Project 13-19 Canberra Avenue, St Leonards

Report NCC Assessment Report (DA Stage)

Reference 220225C-NCC-r5

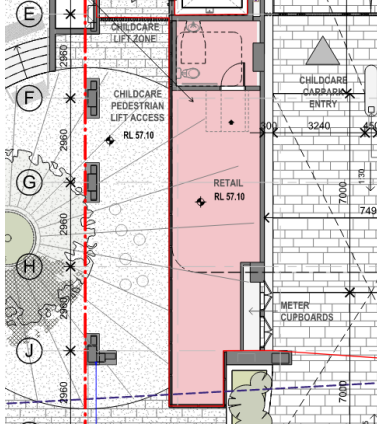
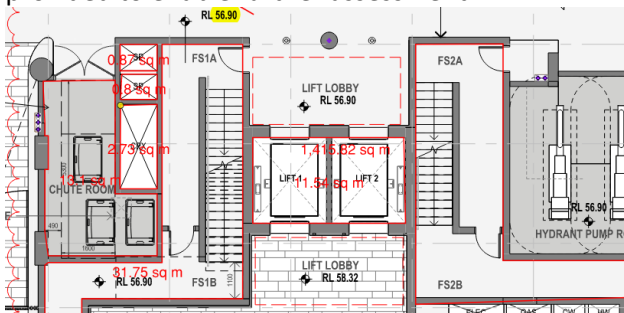
7.	Exit travel distances The following areas have been provided with non-complaint exit travel distances: <u>Ground floor carpark</u> The ground floor park has been provided with a non-complaint distance to a point of choice measured to be 23m in lieu of 20m <u>Upper ground floor</u> The upper ground floor has been provided with a with a non-complaint distance to a point of choice from the swimming pool area, measured to be 28m in lieu of 20m <u>Level 1</u> The travel distance has been measured to be 34m to an exit from the community centre in lieu of 20m to a single exit (being the open space). <u>Residential Levels</u> The exit travel distances within the residential parts of the building level 2 to level 17 have been provided with a	D1.4	DP4 EP2.2

Item	Possible Performance Solution	DtS Provision	Performance Requirements
	non-complaint distance measured at 10m to a point where two exits are available. The exit travel distances do not meet the deemed to satisfy provisions of the NCC and must be assessed on a Performance Basis at construction stage.

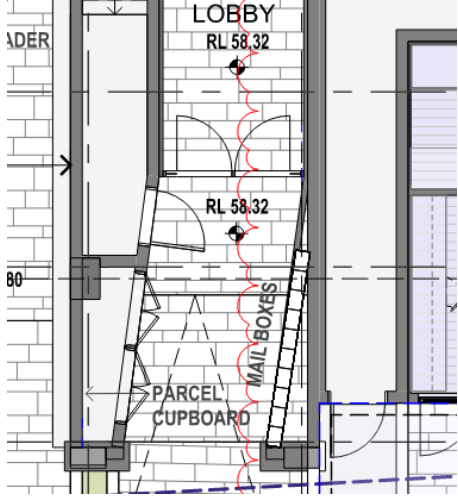
9.	Travel via fire-isolated exits The fire-isolated stairs from the residential levels adjacent the residential lobby discharges within the entry lobby which is under the building line in lieu of discharging directly (or via a fire-isolated passageway) to a road or open space or to a part of a building in accordance with Clause D1.7(b)(ii) or D1.7 (b)(iii). Furthermore the path of travel from the discharge point to open space requires travel pass unprotected openings Clause D1.7(c). This can be supportable via a performance solution with a fire engineer.	D1.7	DP4 EP2.2
10	Travel via Fire Isolated exits – Doors opening into Fire-Isolated Exits In accordance with clause D1.7, a doorway from a room must not open directly into a fire-isolated stairway, or fire-isolated	D1.7	DP4 EP2.2

Item	Possible Performance Solution	DtS Provision	Performance Requirements
	passageway unless it's from an airlock or the like. The Deemed-to-Satisfy provisions are not met as the pump rooms opens directly onto Fire isolated passageway on Ground Floor.		
11	<u>Portable fire extinguishers</u> The Class 2 parts of the building includes two storey sole occupancy units. Clause E1.6 (b) requires portable fire extinguishers to serve only the storey at which they are located. Clause E1.6 (b) requires the portable fire extinguishers the travel distance from the entrance doorway of any sole-occupancy unit to the nearest fire extinguisher is not more than 10 m. On review of the proposed floor plans for the building, this would be a Dts departure. Due to the entry doorways of the ground floor two storey units are on the ground level. Therefore, the provision of a portable fire extinguisher at the main entrance of the sole-occupancy unit would be a technical non-compliance with Clause E1.6 (b) as it will not permit to serve the storeys above.	E1.6	EP1.6
